STATE OF NORTH CAROLINA  
DEPARTMENT OF TRANSPORTATION

Subject: **REVISION to Application for Individual Section 404 Permit and 401 Certification** for the widening of US 321 from SR 1500 (Blackberry Road) to US 221 at Blowing Rock; Watauga and Caldwell Counties; State Project No. 6.739001T; NCDOT Division 11; TIP No. R-2237C, WBS Element No. 34402.2.6

This Application Revision is being submitted to augment the previously submitted application referenced above. This Revision includes responses to comments received in letters from the DWQ and from the USACE, as referenced above, and corrections/clarifications to the original application. This Revision application package consists of the cover letter, attachments for the responses to the USACE comments, a revised EEP acceptance letter, and Revised Permit Drawing Sheets (including revised Wetland Permit Impact Summary sheets) along with the applicable corresponding revised roadway plan sheets.

REVISED 10-5-10  
Permit Drawing  
Sheet 32 of 45

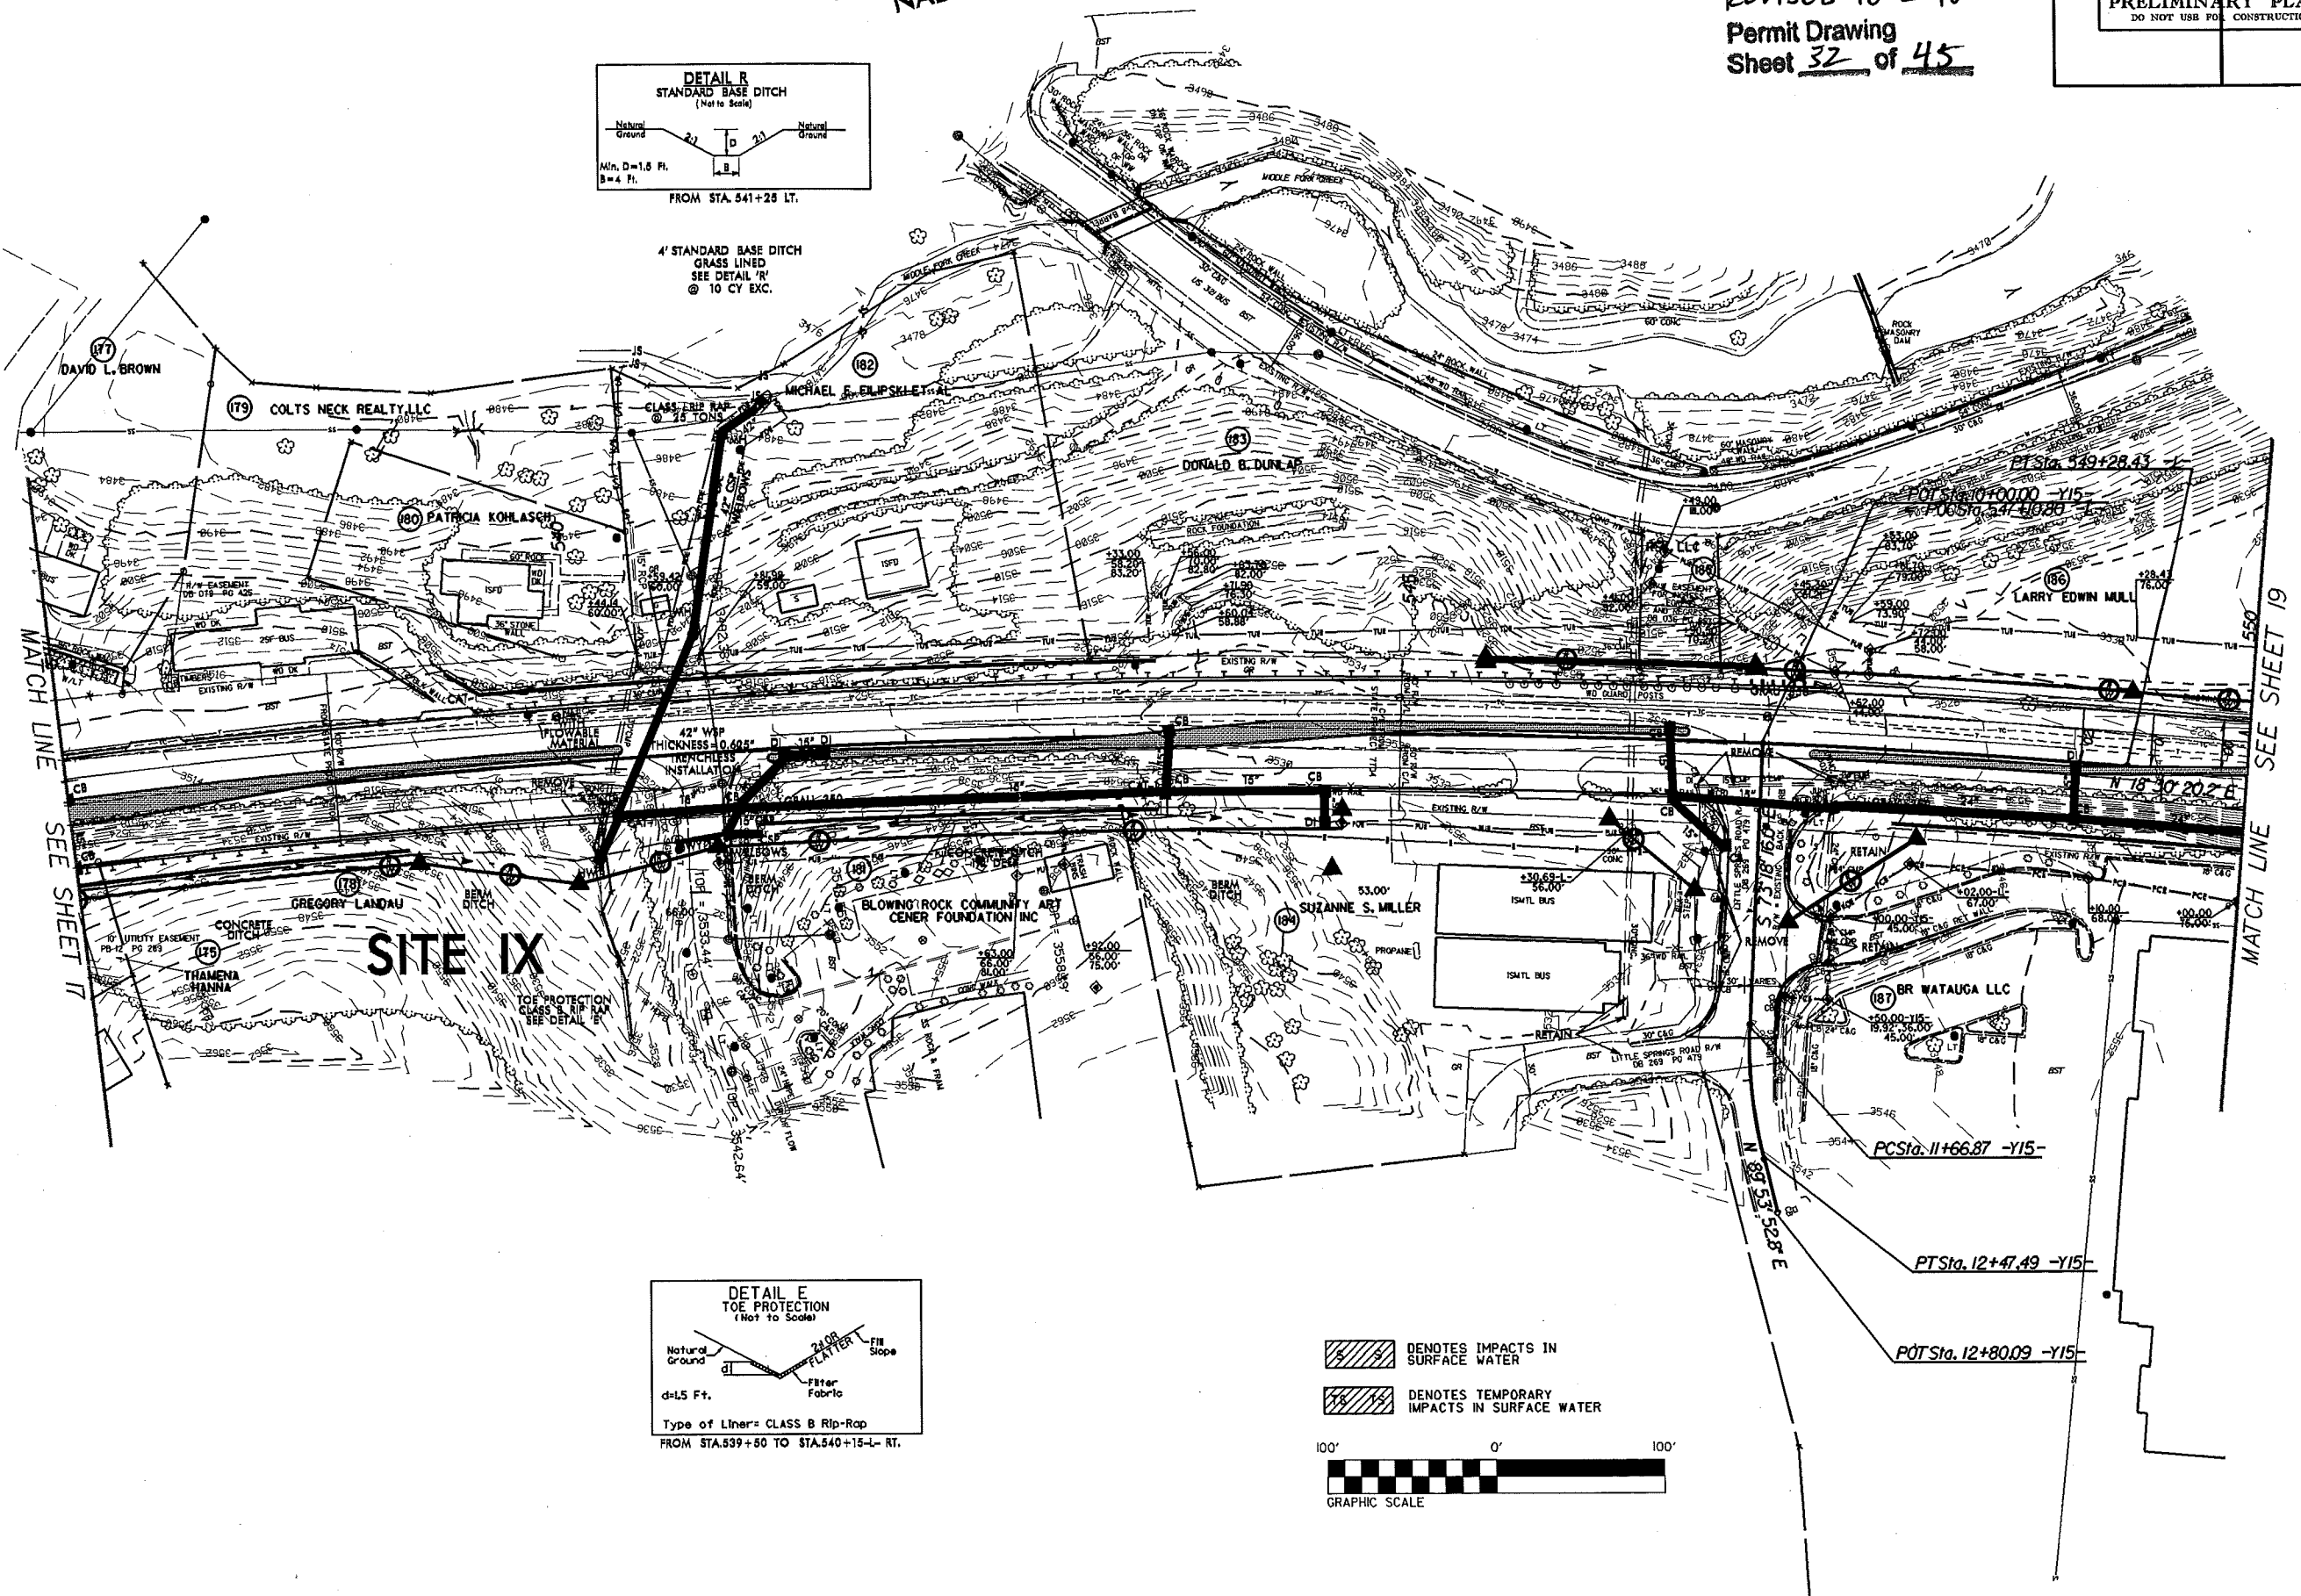
A four-foot base ditch has been included at Site IX to create a direct connection to Middle Fork Creek. The permit drawings for Site IX have been revised accordingly. See Permit Drawings Sheets 31-33 of 45. The connection should be able to be constructed with no additional impacts to the streams.

4' STANDARD BASE DITCH  
GRASS LINED  
SEE DETAIL 'R'  
@ 10 CY EXC.

REVISED 10-5-10  
Permit Drawing  
Sheet 34 of 45

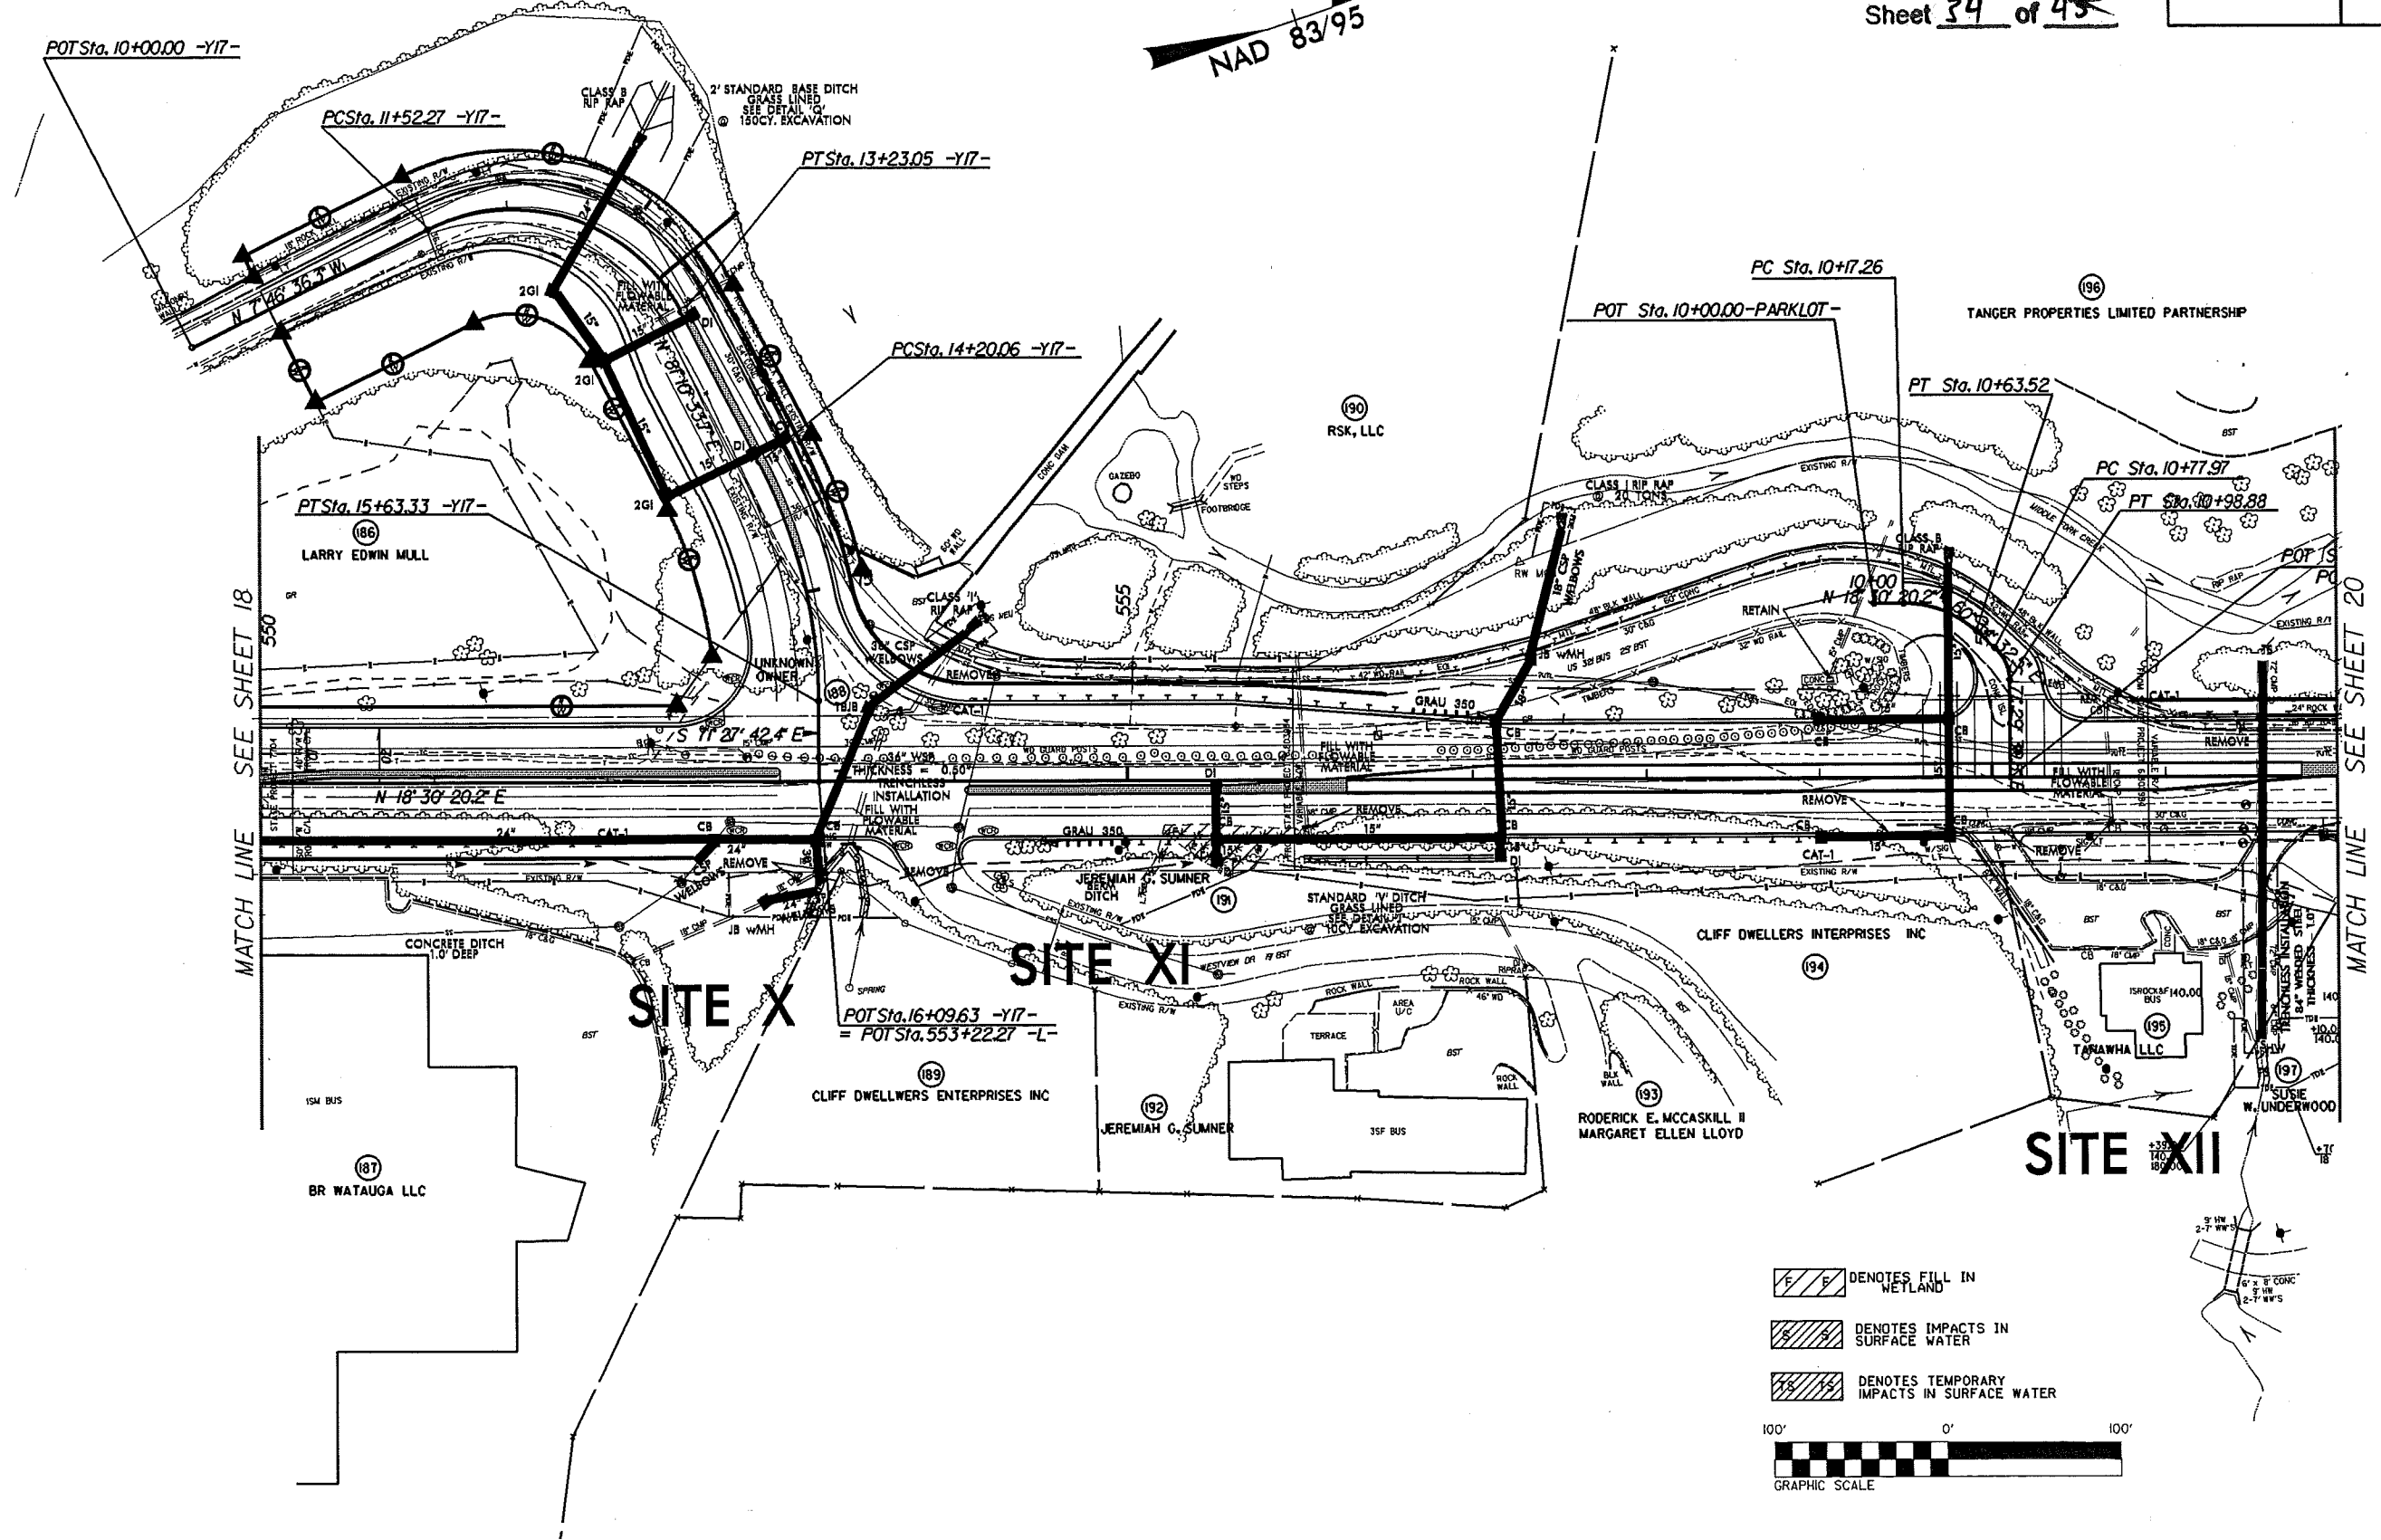
At Site X in the original application submittal, UT3 to Middle Fork Creek was proposed to be piped to the stormwater system. The impacts at this site did not include impacts that would have occurred to the downgradient segment of UT3 to Middle Fork Creek located between US 321 Business and Middle Fork Creek (this segment of UT3 to Middle Fork Creek was not included on the design plans). Due to the grade at the pipe outlet on the west side of US 321 Business, riprap is proposed to be placed in the stream channel to reduce erosion, resulting in a net increase of 10 lf of permanent stream impacts to UT3 Middle Fork Creek (Note: 98 lf of stream impacts were avoided). See Revised Permit Drawing Sheets 34-36 of 45, and the applicable corresponding revised roadway plan sheet number 19. The revisions at Site X are summarized below (and presented in revised Table 4 of this application):

- UT3 to Middle Fork: 59 lf (revised from 49 lf)
  - UT4 to Middle Fork: 25 lf (unchanged)
- Total for Site X = 84 lf (revised from 74 lf)
